ZONING CHANGE REVIEW SHEET

CASE: C814-2014-0110.02.SH

ADDRESS: 7900 Loyola Lane
Austin, Texas 78724

Project Name and Proposed Use: 7900 Loyola Lane. C814-2014-0110.02.SH. Project: Colony Park Sustainable Community Initiative PUD. A PUD amendment on 208 acres of land to update the Land Use Plan, permitted uses, maximum densities and site development regulations. Related item: Council Resolution # 20230608-053. Amend the Colony Park Plan to make it less prescriptive by: Restructuring the PUD to be more flexible and less prescriptive to better respond to unforeseen opportunities and changing market conditions and to adapt to the 2020 Land Use Plan. Reconfiguring the buffer areas and setbacks for the Critical Environmental Features (CEFs) to create a more cohesive and efficient land use plan. Reducing the number of street sections and bringing them into alignment with the Transportation Criteria Manual. Refining parking requirements to bring them into conformance with current market conditions. Adding Equitable Transit-Oriented Development. Making adjustments to the Open Space Plan, while maintaining a minimum of 41.63 acres (20% of the site) in parks and open spaces. Refining parki

EXHIBIT G (PAGE 3)

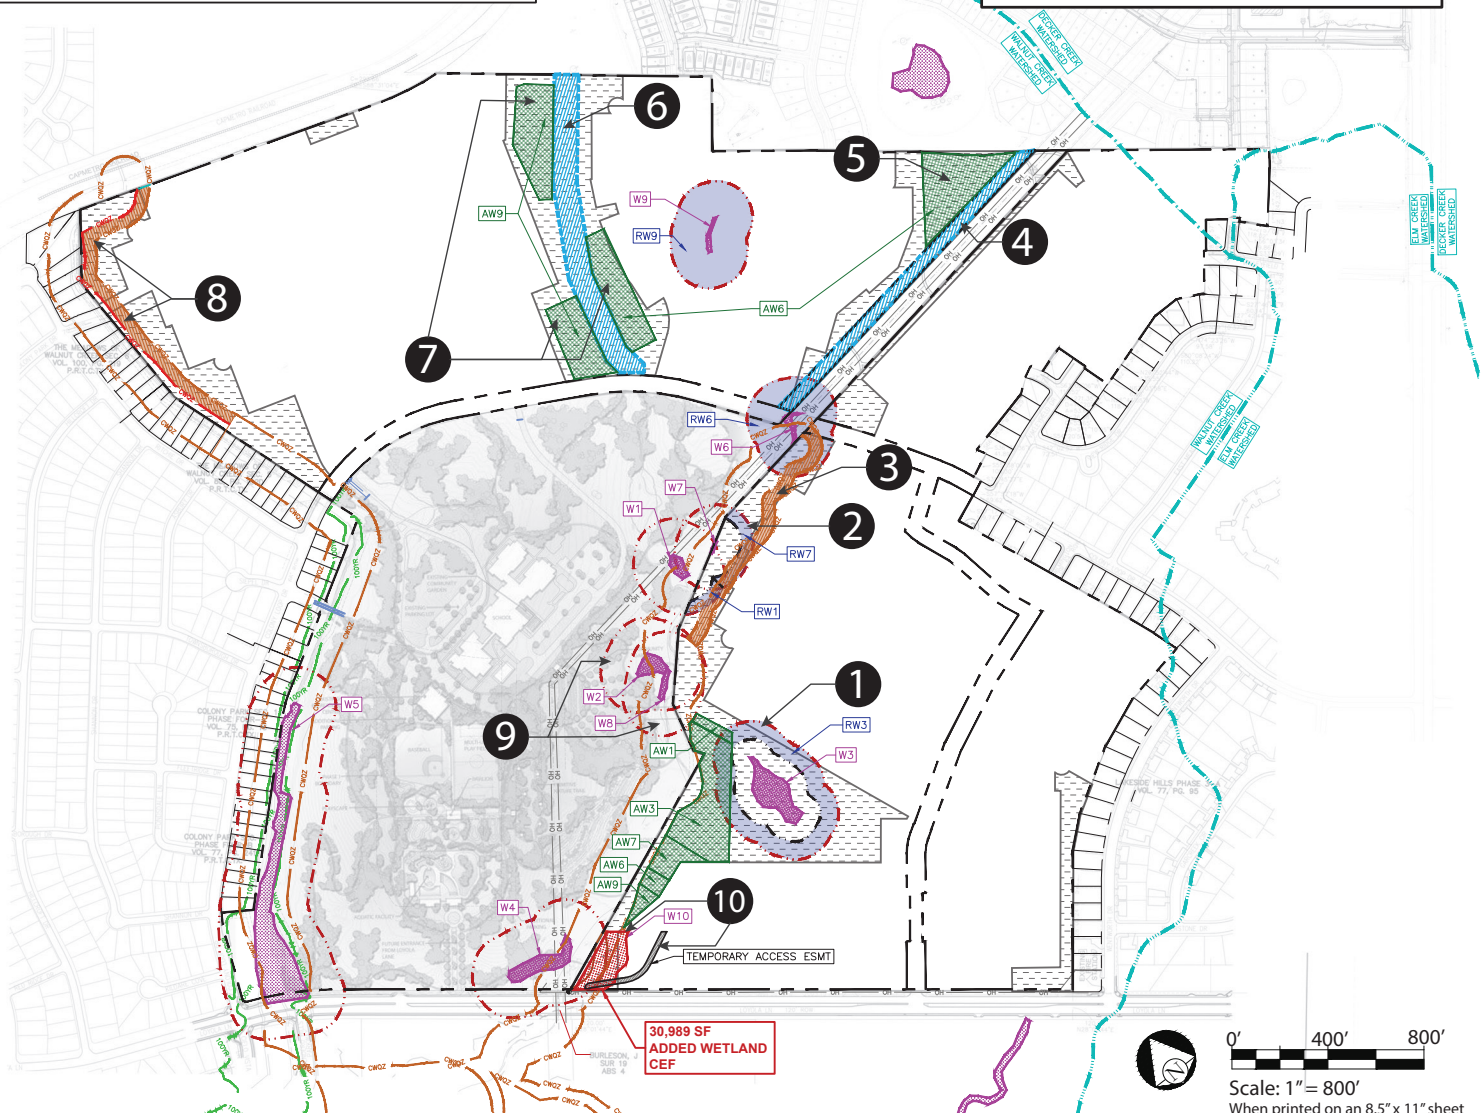
EV 16 Revise note #8, Exhibit G (page 3) as shown.

3. The CWQZ related to existing classified waterways has been modified as shown in Exhibit G. ~~and shall be exempt from all future CWQZ changes to currently unclassified waterways.~~ Additional protected headwater areas have been added. ~~These~~ mitigate for CWQZ reductions. (as shown in Exhibit G) ~~by providing protections for currently unclassified waterways.~~ Additional protected headwaters shall not be subjected to CWQZ regulations. Additional protected headwater areas (designated in Exhibit G) are vegetated drainage conveyance areas draining less than ~~320~~ 64 acres ~~that promote healthy soils and vegetation along the creek corridor and allow the stream adequate space to migrate over time, thus controlling flood impacts, promoting water quality, and providing multiple community benefits. designated in Exhibit G established to enhance water quality.~~ Permitted activities and development in these areas ~~include~~ is limited to grading with revegetation, limited roadway crossings, trails and park amenities, ~~utilities and~~ utility crossings, ~~and water quality facilities.~~

- “The CWQZ related to existing classified waterways has been modified as shown in Exhibit G and shall be exempt from all future CWQZ changes to currently unclassified waterways.”

- 64 acres of drainage is the current definition of a minor classified waterway. The designated headwaters drain less than 64 acres.
- “Grading with revegetation” sounds like a grass-lined channel. If this is the intention, it needs to be designed with WPD so that it mimics the features of a natural channel, including sinuosity and all the things listed in note #12, Exhibit G (page 3) – “...The restoration would at a minimum need to provide grade control structures that stabilize the channels and include the installation of check dams, cobble riffles, seepage berms, and in-stream installation of root wads and large woody debris.”

EXHIBIT H

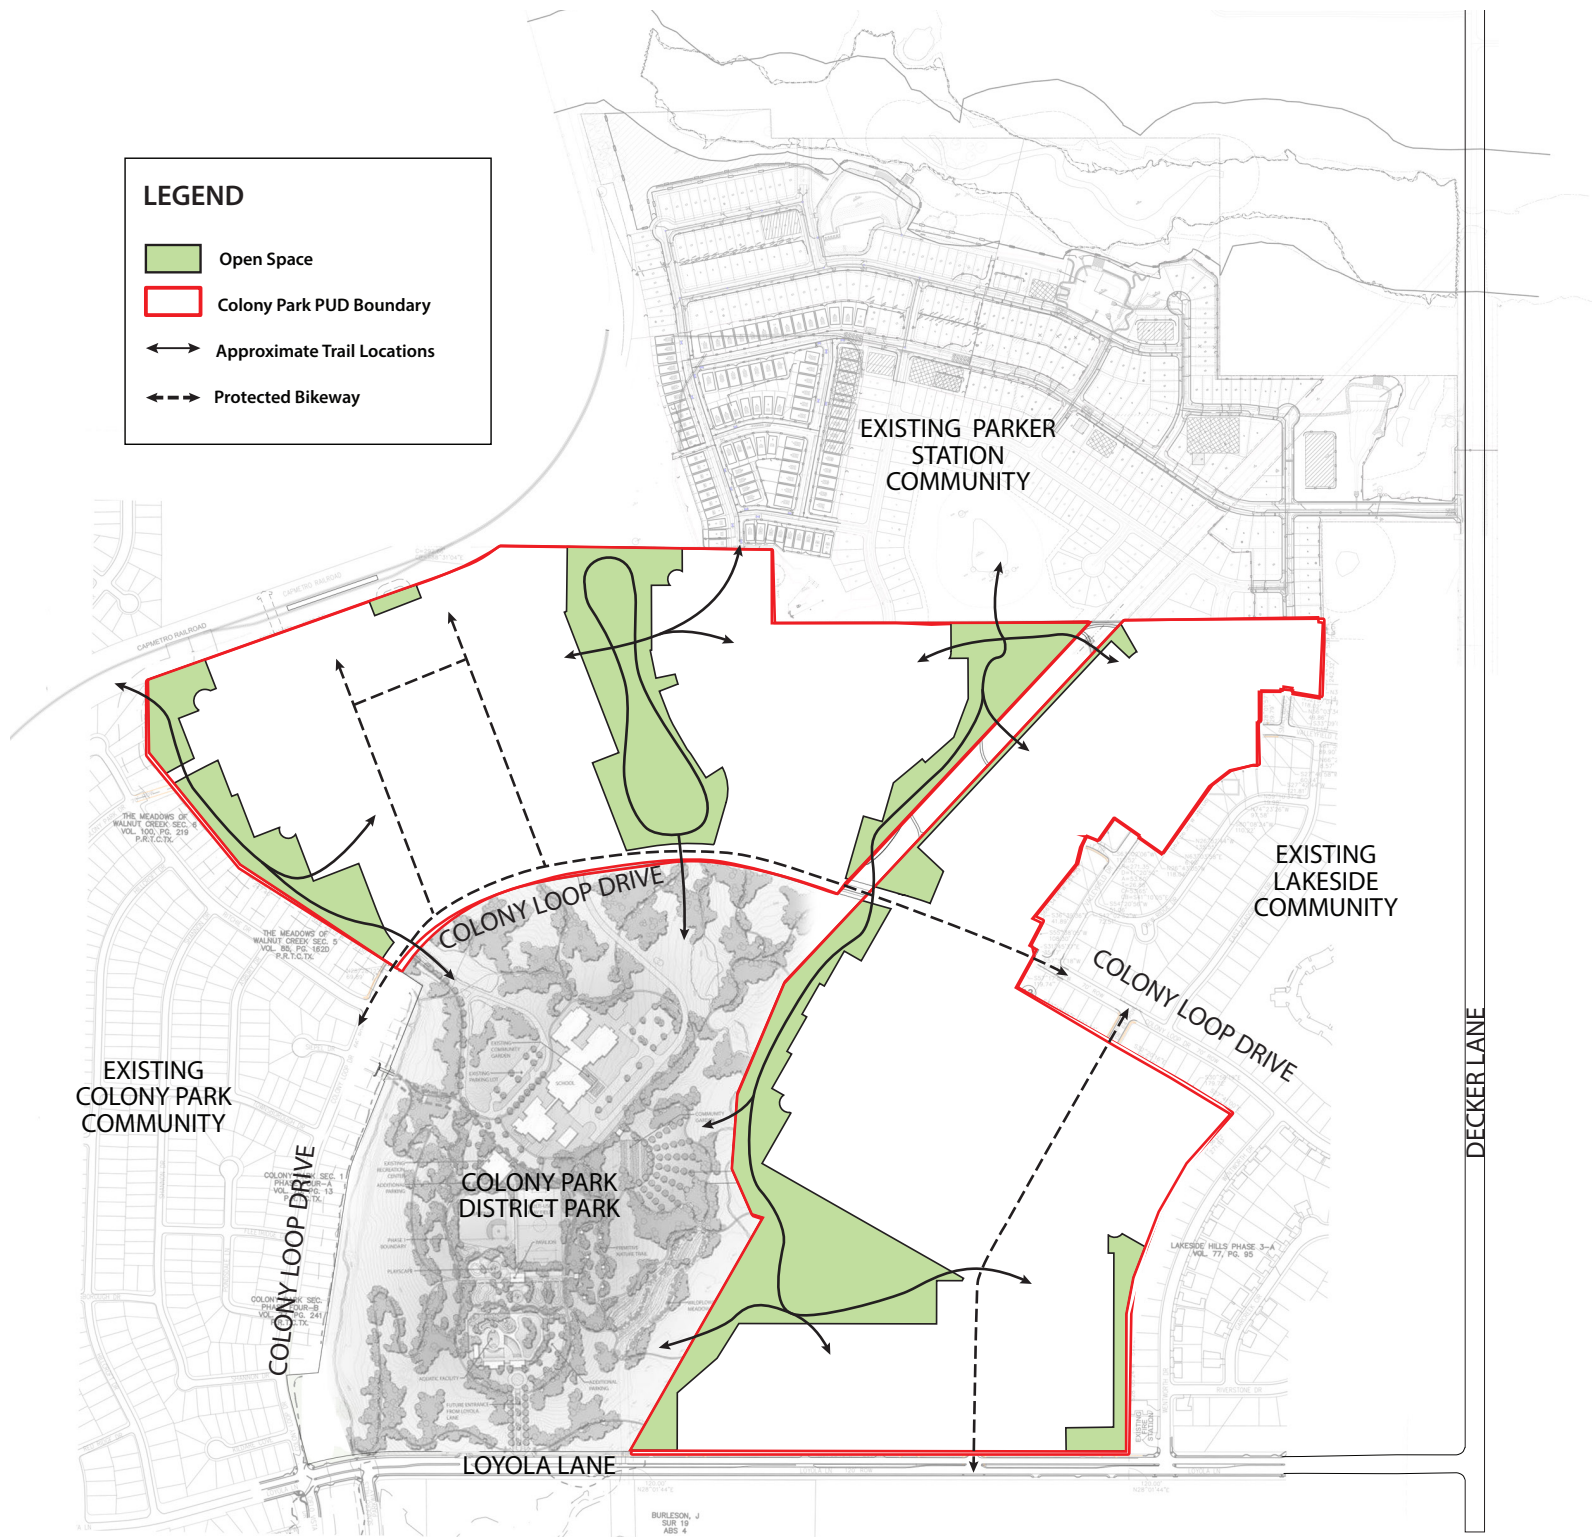
U1: Note explicitly on the parks and open space plan, environmental exhibits, and in code modifications that the parks amenities contemplated are allowed by right within the open space areas, with the exception of the wetland identified by the environmental reviewer in the southern portion of OS-1, south of the convergence of the creeks; divide OS-1 into two OS areas, OS-1 and OS-1.1 (for the southern area just noted along the Central Health site), and denote restrictions to amenities within OS-1.1.

U1: Note explicitly on the parks and open space plan, and in code modifications that the parks amenities contemplated are allowed by right within the open space areas, with the exception of the wetland identified by the environmental reviewer in the southern portion of OS-1, south of the convergence of the creeks; divide OS-1 into two OS areas, OS-1 and OS-1.1 (for the southern area just noted along the Central Health site), and denote restrictions to amenities within OS-1.1.

Colony Loop Drive

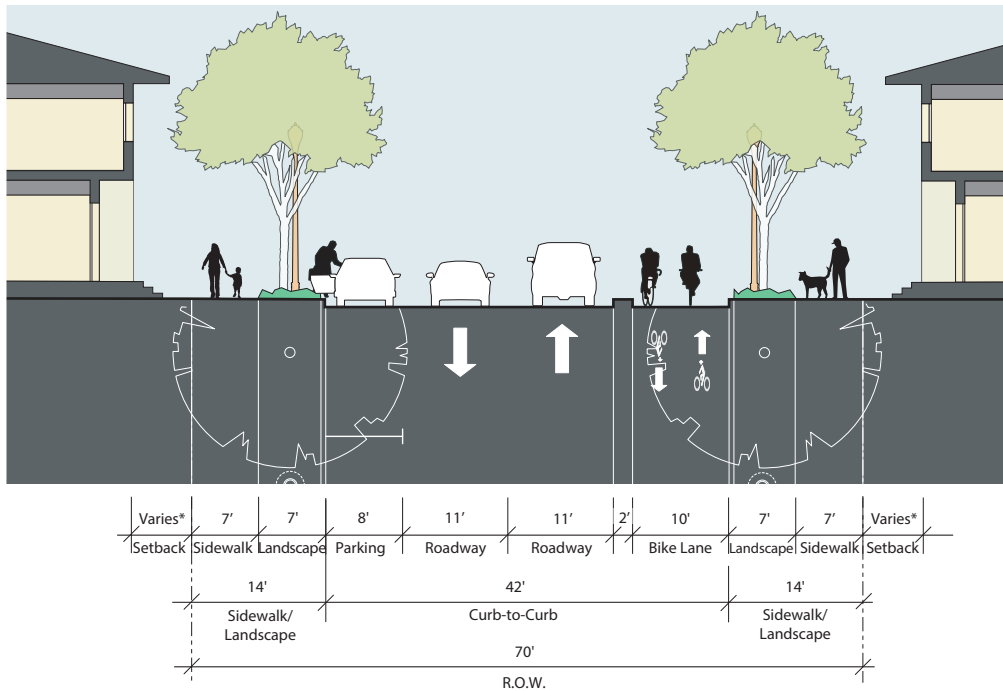
U2: Comment cleared. Please note the discrepancy between the 70' ROW identified under Exhibit I (pg. 28) and a 72' Colony Loop Drive cross section shown Exhibit I (pg. 30). ATD recommends the 72' ROW, consistent with the ASMP, and revising bike facility to the TCM recommended 10' minimum, which the applicant had previously agreed to.

PROPOSED ASMP MODIFICATIONS

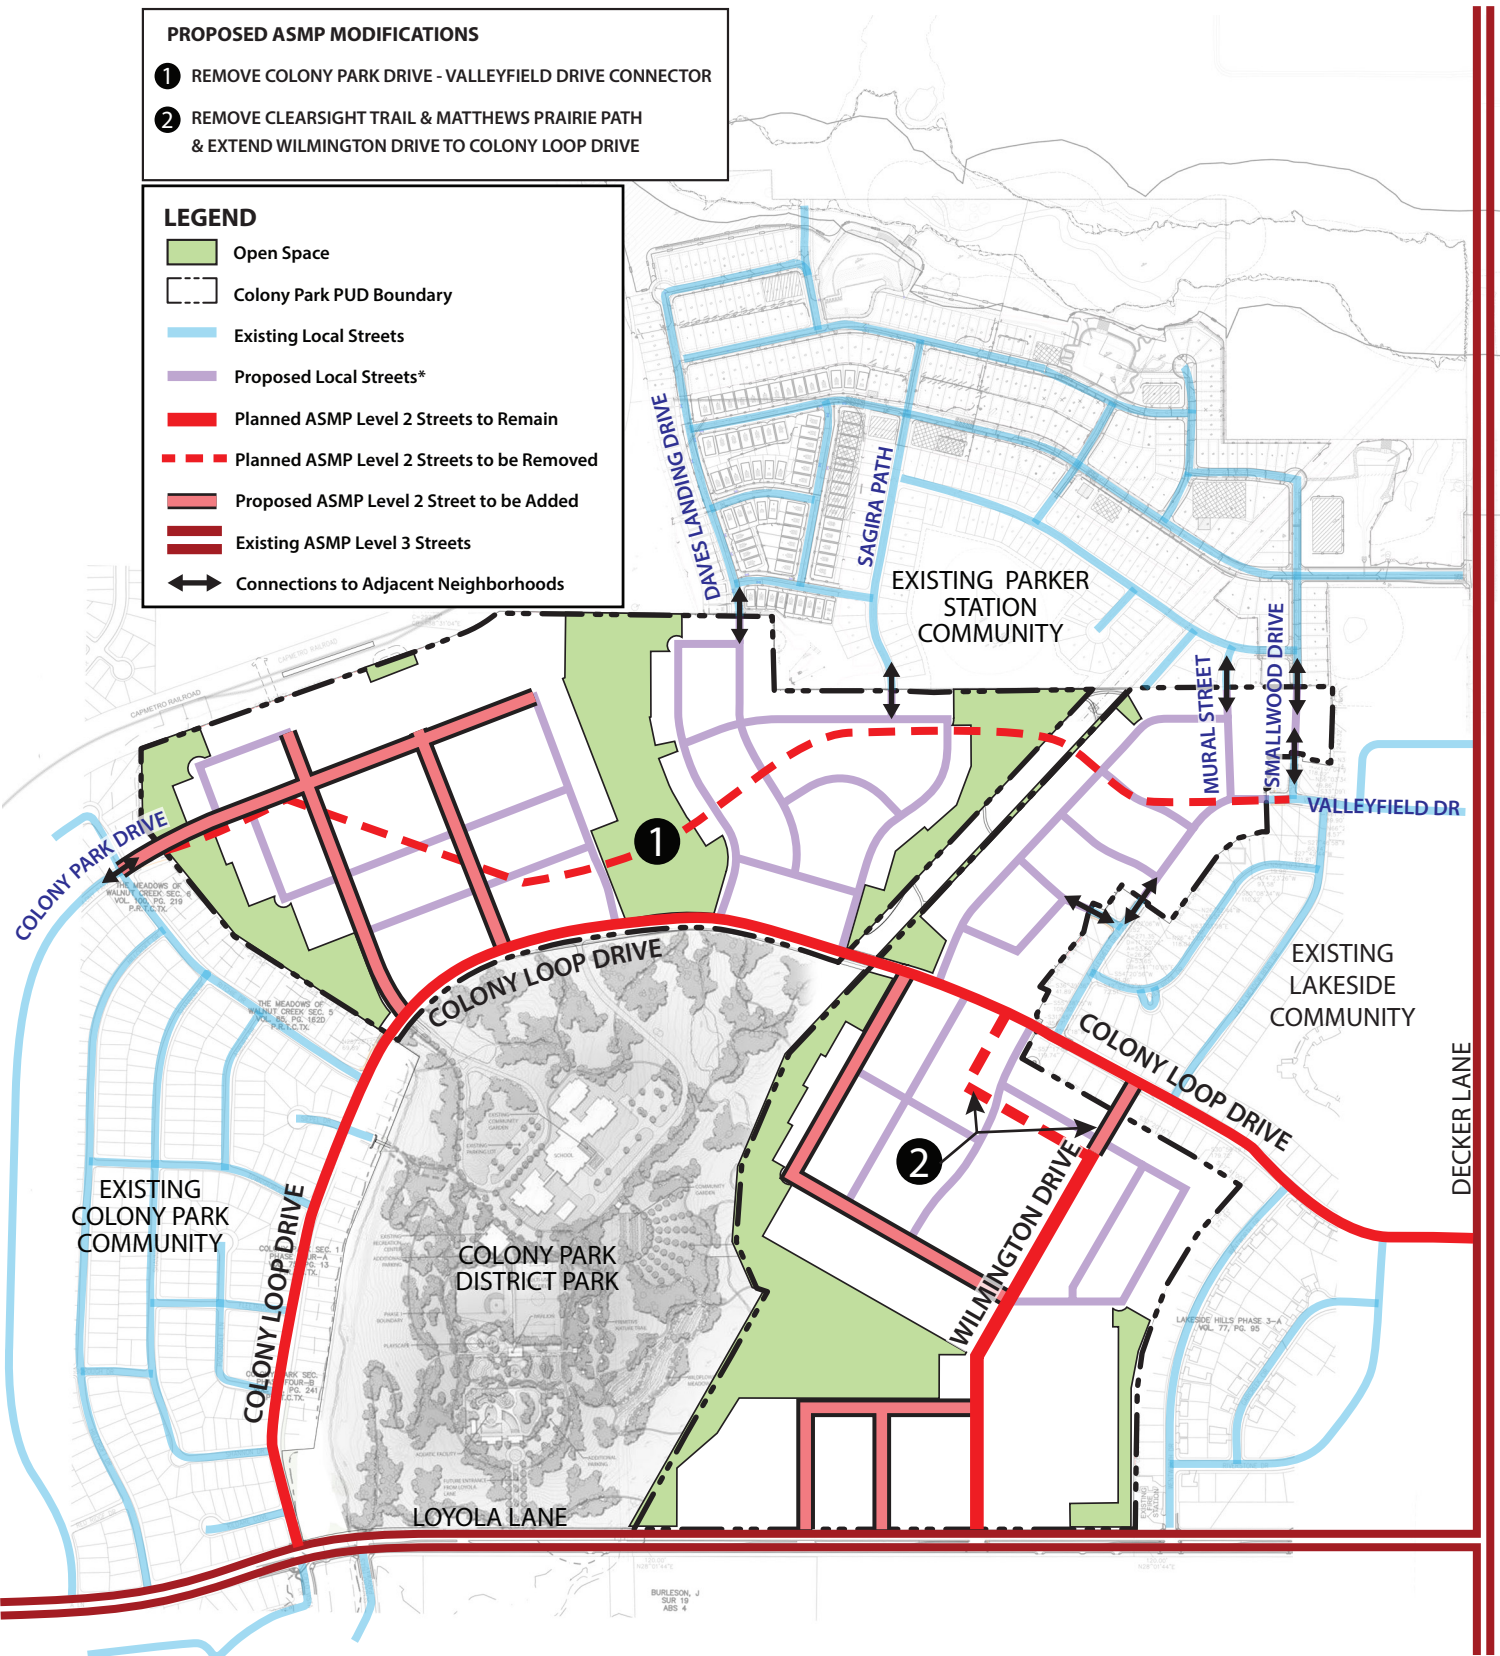
U1: Comment cleared. ATD recommends requested waiver for this ASMP roadway.

U1: Comment cleared. ATD recommends requested waiver for this ASMP roadway.

U1: Comment cleared. ATD recommends requested waiver for this ASMP roadway.

Special Detail 01 - Street Tree Placement & Allowable Clearance from Underground Electric

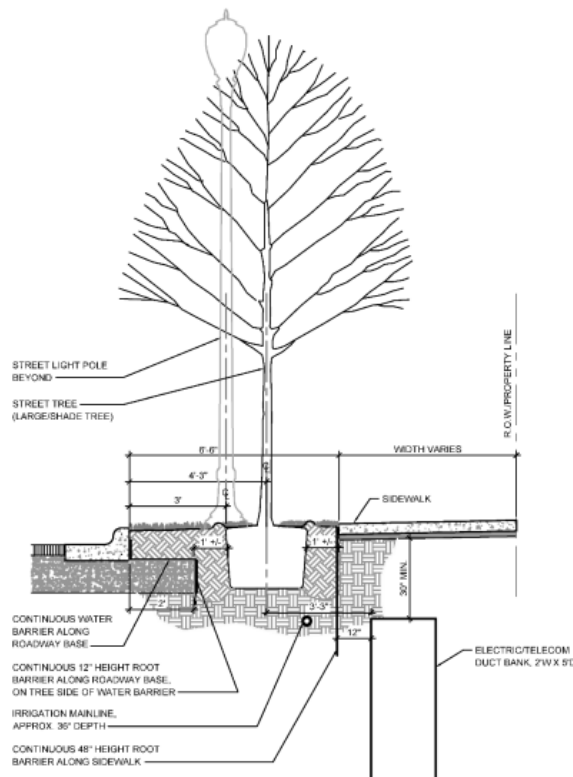
Note: The U2 Draft PUD (Pg. 40) Exhibit K – F. Special Detail has the correct detailed attached. It depicts the solution AE and other COA utilities agreed upon moving AE facilities within the roadway.

- The U2 Exhibit K edits 9/25/23 and U2 Exhibit K Final 9/25/23 have the incorrect “F. Special Detail” attached. Please replace to match the one shown/provided in the U2 Draft PUD.
- Incorrect detail:

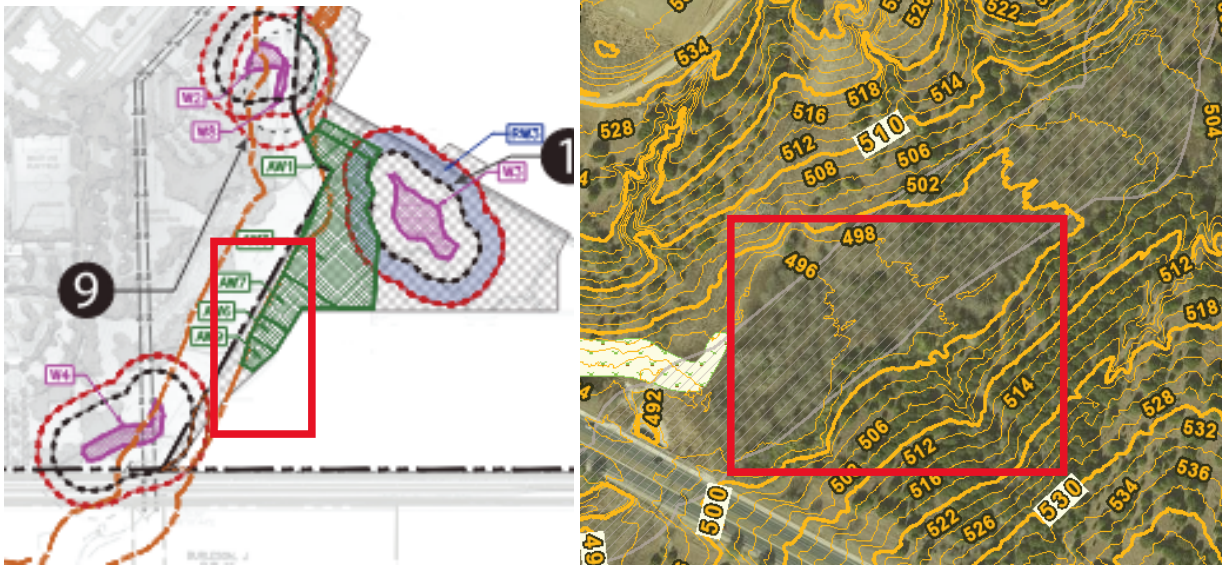
WB6 Update 0. The representation of removed/reduced/modified wetland CEFs and CEF buffers is difficult to track. Please adjust the symbology to clarify CEF/CEF setback areas removed and or added. Additionally, please add a table documenting the changes in area for each wetland CEF separately.

Update 1. Partially addressed. Include the following changes to the environmental Exhibit G

1. Distinguish between mitigation designated for the wetland CEF and the wetland CEF setback. The balance table should reflect the reduction and addition of CEF and CEF buffer in separate columns.
2. The wetland CEF mitigation should be added to the area spanning the CWQZ and the 500' elevation line (see below) . This area contains the undelineated mosaic wetland features described in the original WPD site analysis for the Colony Park PUD.

3. Please remove any extraneous line work from the exhibit unless it indicates a reduction or addition of area (see example below showing red X's).

RESPONSE: It is our understanding that John has agreed this comment is not necessary at the meeting and should withdraw this comment with no further action.
